187th session

Proposal for Supplement 21 to the 04 series of amendments to UN Regulation No. 48 (Installation of lighting and light-signalling devices)

Submitted by the Working Party on Lighting and Light-Signalling*

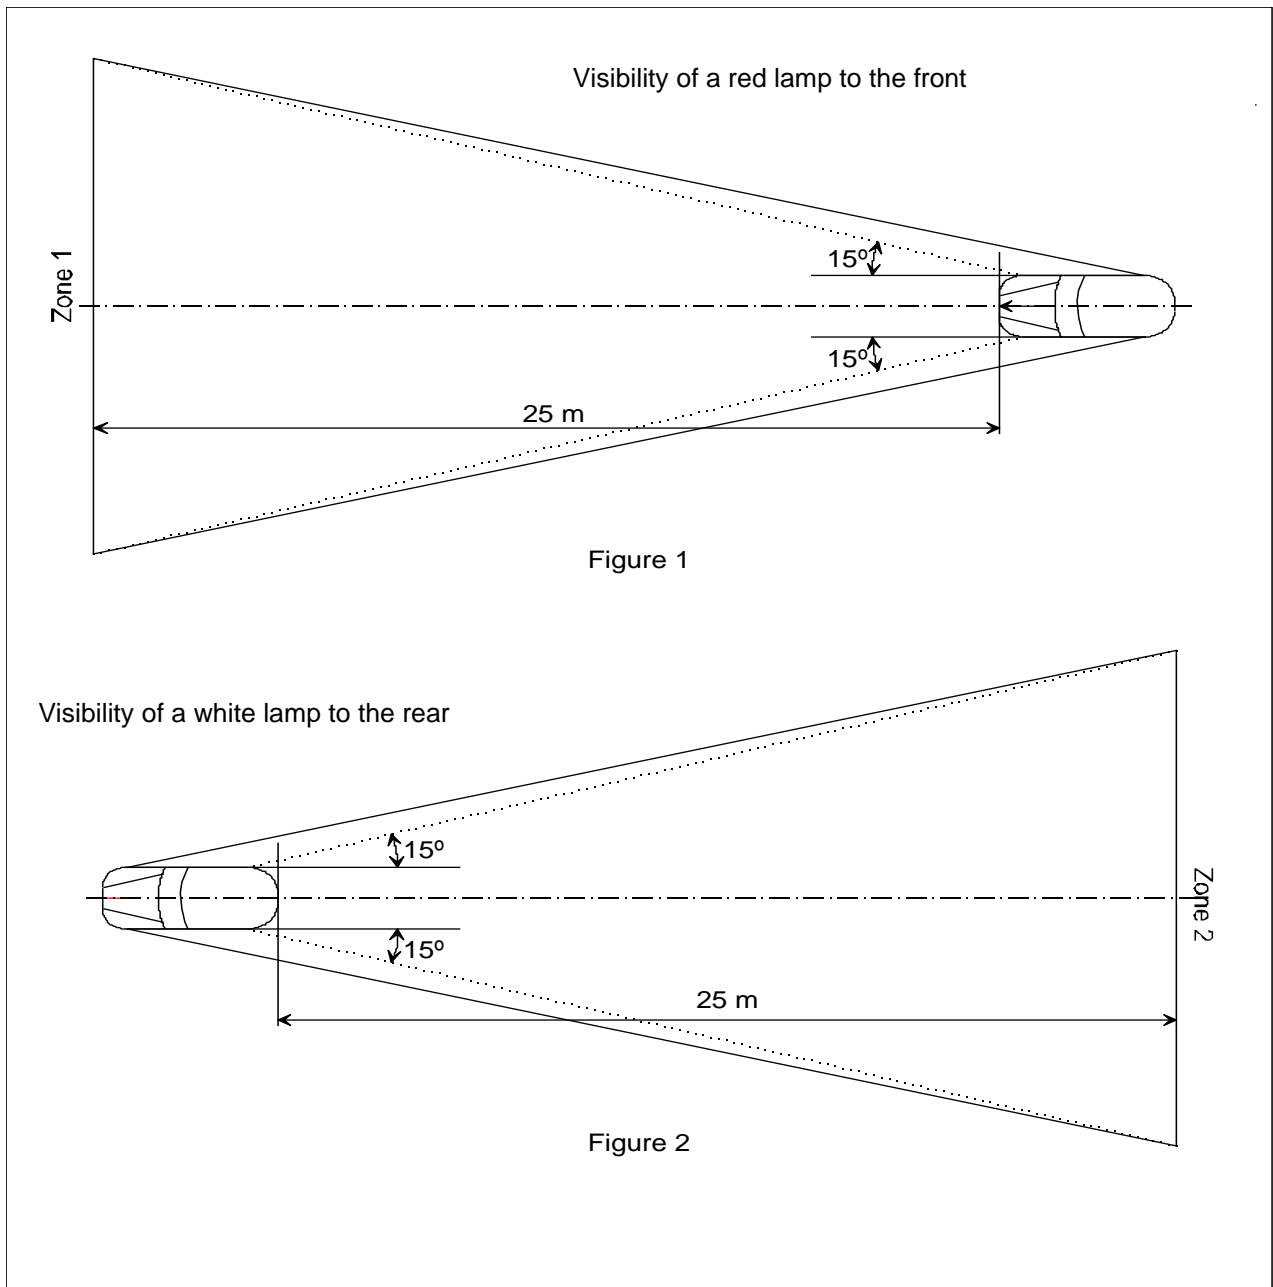
Paragraph 6.26.9.2., amend to read:

“6.26.9.2. At the request of the applicant and with the consent of the Technical Service the requirement of 6.26.9.1. may be verified by a drawing or simulation or deemed be satisfied if the installation conditions comply with paragraph 6.2.2.

of UN Regulation No. 23 or paragraph 5.10.2. of the 00 series of amendments to UN Regulation No. 148 or paragraph 5.10.1.2. of the 01 and subsequent series of amendments to UN Regulation No. 148, as noted in the communication document in Annex 1, paragraph 9."
